2018 Basin Boundary Modifications - Final

Basin(s): 1-004 SHASTA VALLEY

Requesting Agency: Siskiyou County Flood Control and Water Conservation District

DWR Final Decision: Approve

Basin(s): 3-012 SANTA MARIA

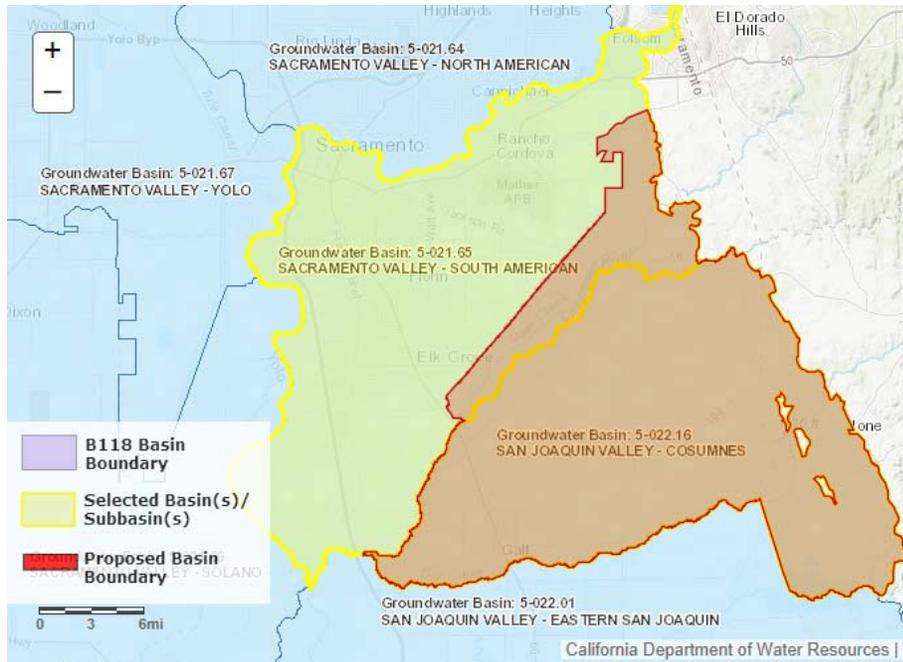
Agency Description: Scientific External Modification of the Santa Maria Groundwater Basin to eliminate fringe areas.

Basis for Decision: The basin boundary modification would revise external boundaries and remove areas outside of the Santa Maria Basin adjudication boundary within the Santa Barbara County portion of the Santa Maria Basin. The request includes four components: Southwestern fringe, Orcutt Hill fringe, Sisquoc River fringe, and Tepusquet Creek fringe. The request does not fully meet the requirements of the regulations.

The Southwestern fringe part is denied due to discrepancies between the requested linework and the submitted geologic maps. The Orcutt Hill fringe part is denied due to insufficient information and data to accurately determine where groundwater flow direction changes along the Soloman Hills anticline. The Sisquoc River fringe portion of the request is denied due to the clear hydrogeologic connection between the alluvial units present within the Sisquoc River fringe area and the Santa Maria Basin adjudicated area. The Tepusquet Creek fringe part is denied due to alluvium in the fringe area being greater than 25-feet thick, and a clear hydrogeologic connection between the alluvium in the Tepusquet Creek fringe area and the Santa Maria Basin adjudicated area.

Basin(s): 5-021.65 SACRAMENTO VALLEY - SOUTH AMERICAN; 5-022.16 SAN JOAQUIN VALLEY - COSUMNES

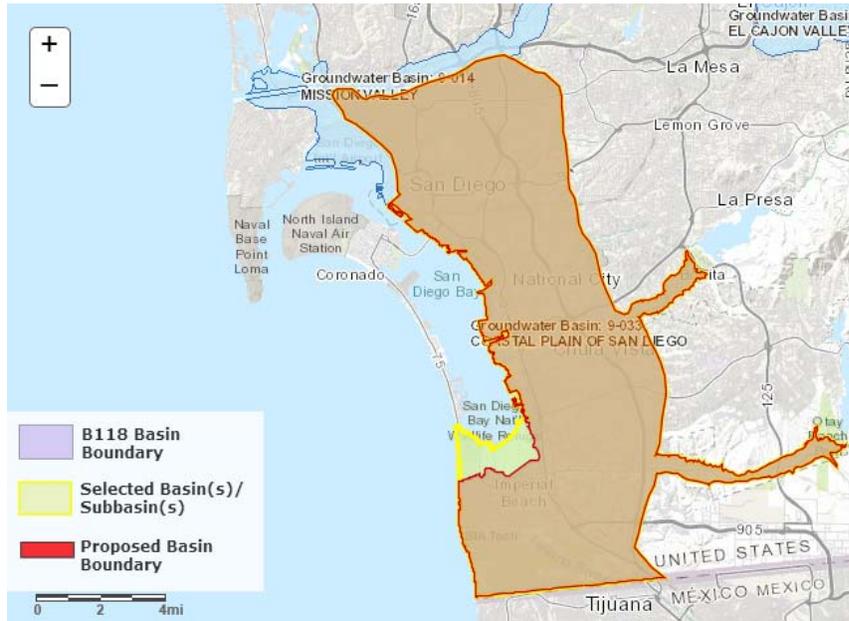
Agency Description: Shift the South American and Cosumnes subbasin boundary approximately two to four miles.

Basis for Decision: The boundary modification would revise a portion of the shared boundary between the Cosumnes and South American subbasins to expand and incorporate the jurisdictional areas of Sloughhouse Resource Conservation District and (SRCD) and Omochumne-Hartnell Water District (OHWD). The revised boundary would then follow the northern boundaries of the SRCD and OHWD jurisdictional boundaries. Four letters of support and two letters of opposition are associated with the request. Letters of opposition were provided by the Sacramento Central Groundwater Authority and the City of Sacramento. Five public comments (3 support, 2 oppose) were submitted on draft decision to deny the modification. The requesting agency did not sufficiently demonstrate the proposed modification would result in improved groundwater management. The request does not fully meet the requirements of the regulations.
